# Access Compliance Report

## Public Rights-of-Way

### (Curb Ramps)

Intersection ID: 31712	Main Street: ALDER_CT	Cross Street: BUTTONWOOD_CT	Location:	N
ADA ID: C1DF8BCC50FF	Ramp Type: PerpDiag	Initial Pass/Fail: Fail	Overall Compliance: No	Severity Score: 13.75
Codes/Mitigation Info/Possible Solution		Field Measurements/Component Compliance

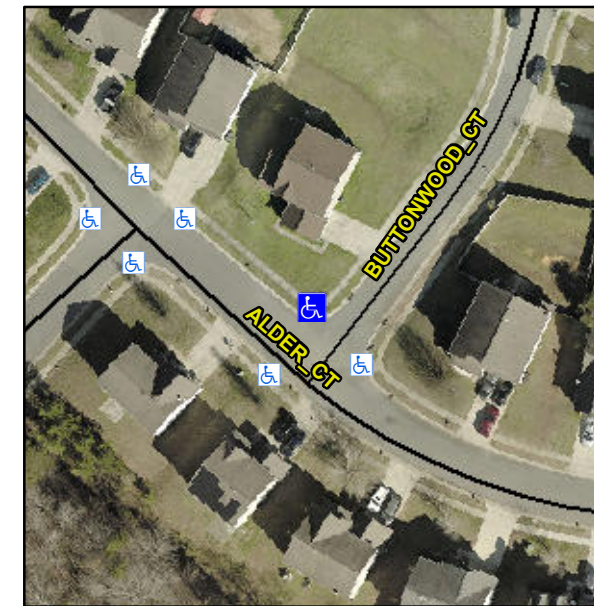
**Not Found, R304.2.2, R304.5.3**

Compliance	Description	Data	Compliance	Description	Data
N/A	Ramp Length (in)	48.0	No	Ramp Slope (%)	9.3
Yes	Ramp Width (in)	48.0	No	Ramp XSlope (%)	3.9
N/A	Flare Type LT	N/A	N/A	Flare Type RT	N/A
N/A	Flare Slope LT (%)	N/A	N/A	Flare Slope RT (%)	N/A
N/A	Flare Traversable LT?	N/A	N/A	Flare Traversable RT?	N/A
N/A	Landing Length (in)	N/A	N/A	DWS Provided?	N/A
N/A	Landing Width (in)	N/A	N/A	DWS Contrast?	N/A
N/A	Landing Slope (%)	N/A	N/A	DWS Length (in)	N/A
N/A	Landing X Slope (%)	N/A	N/A	DWS Full Width?	N/A
N/A	Landing Curb? (Y/N)	N/A	N/A	DWS Offset (in)	N/A
N/A	Shared Landing?	N/A			
N/A	Gutter Ponding?	N/A	N/A	Gutter Slope (%)	N/A
N/A	Gutter Lip Ht (in)	N/A	N/A	Gutter X Slope (%)	N/A
N/A	Painted X Walk1?	No	N/A	Painted X Walk2?	No
	X Walk 1 Direction	To SW		X Walk 2 Direction	To SE
N/A	X Walk 1 Width (in)	N/A	N/A	X Walk 2 Width (in)	N/A
	X Walk 1 Slope (%)	0.2		X Walk 2 Slope (%)	4.7
	X Walk 1 X Slope (%)	5.3		X Walk 2 X Slope (%)	2.1

**Remove & Replace Curb Ramp With Two New Directional Ramps or Equivalent.**
